Owner Change Order (OCO)

Project Name: Brookline - Driscoll  
School  
Gilbane Project No.: J08864.000

OCO: OCO-0043

The Contract changes as follows:  
Scope Of Changes: OCO 43 Misc. Changes  
Description: November Change Order for ATPs 447 and 449

Gas Line at Tree Pits

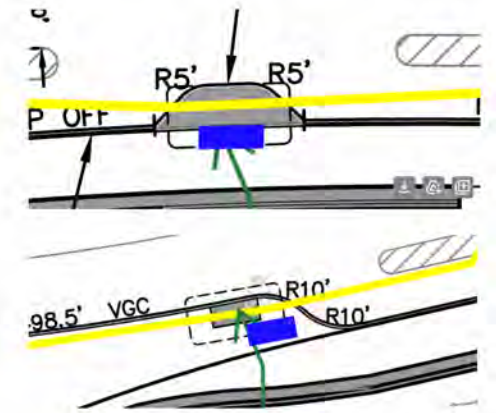
As discussed in the field on 9/10/24, the tree pits are to be deleted or relocated back to avoid the gas line and to align with the other tree pits. As the tree pits are already dug, the filling in of these is owned, but re-digging the new pits and changing form work would be a change. Please confirm this is acceptable. Additionally, please confirm deleting the two tree pits is acceptable with Tom Brady (Town of Brookline Tree Warden).

It is acceptable to the design to do the remedial work as shown on the sketches in this response or to eliminate one or both of the trees. It is our understanding that there is one abutter with particular interest in having a tree planted in the sightline of their property. The decision should go to the Town of Brookline.

**C-2.0**

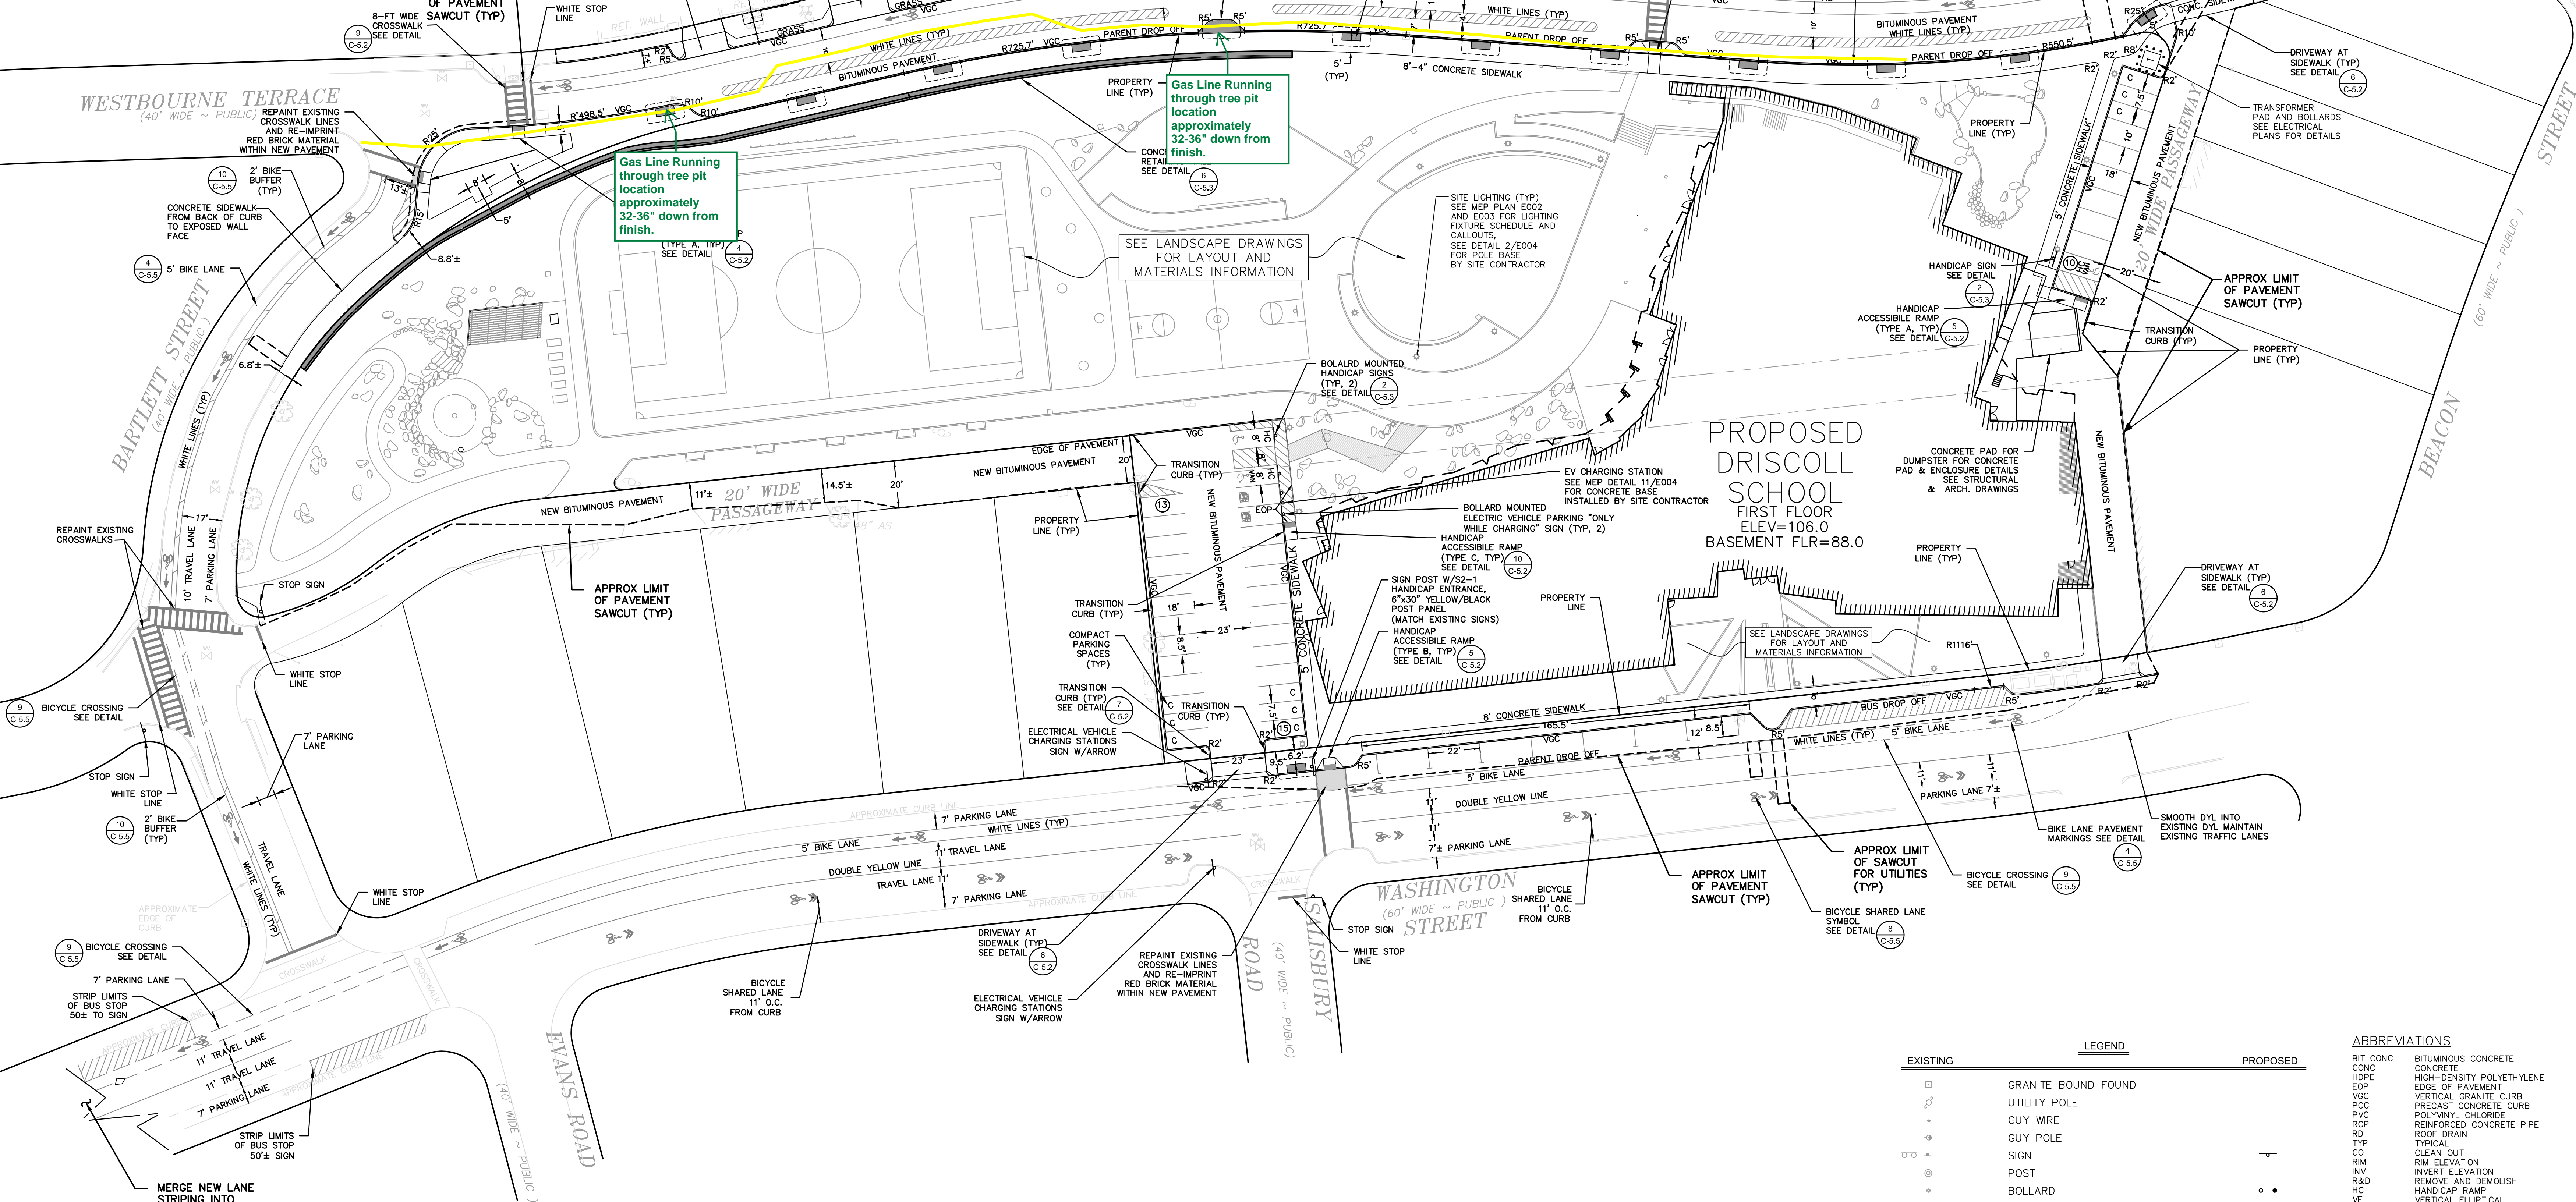
DESCRIPTION:This ATP represents the cost associated with sawcutting the already placed sidewalk, excavating to allow for a new tree pit, and installing the sidewalk in the existing tree pit, per RFI 873. The cost is only for relocating the tree pit at the middle of Westbourne Terrace, and pricing for the other relocated tree pit near the bump out can be provided in a separate ATP if requested by the town.

Ball Valve Curb Stop - (B44-xxx-Q-NL style)

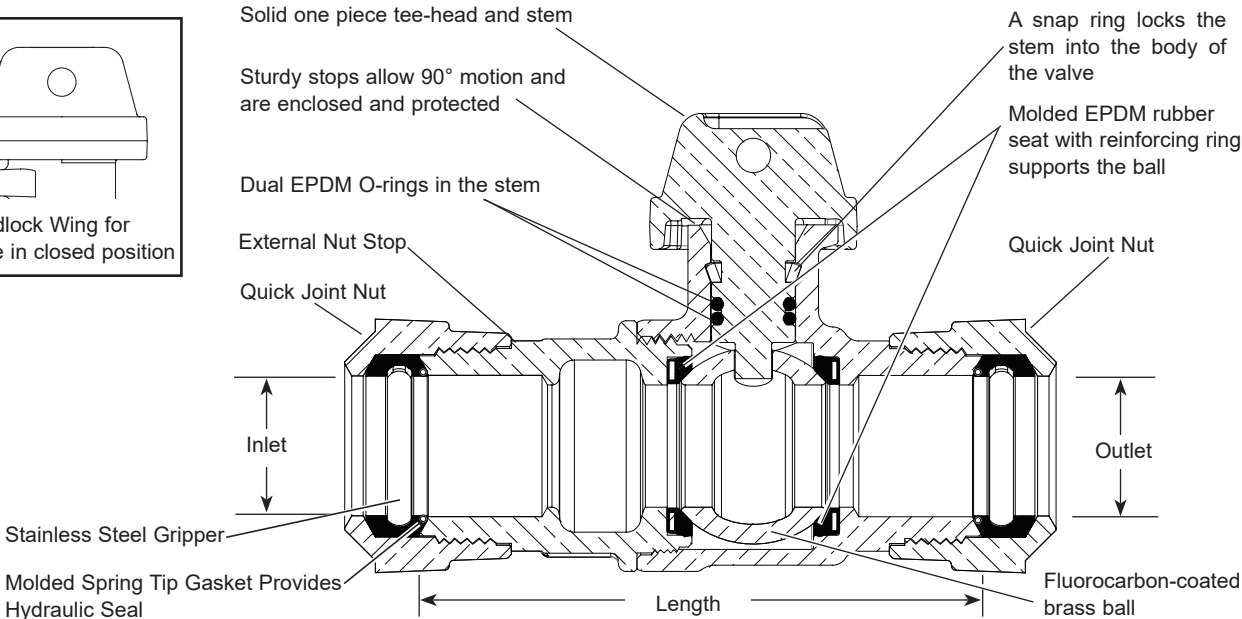
Additional costs associated with providing valves specified in section 33 10 00 in lieu of valves in plumbing section as noted in RFI-866 response.

3. In general terms a curb box/valve generally refers to the box/cover that allows access to the valve. The specific valve per Spec 33 10 00,2.7 are gate valves, and standard town requirements.
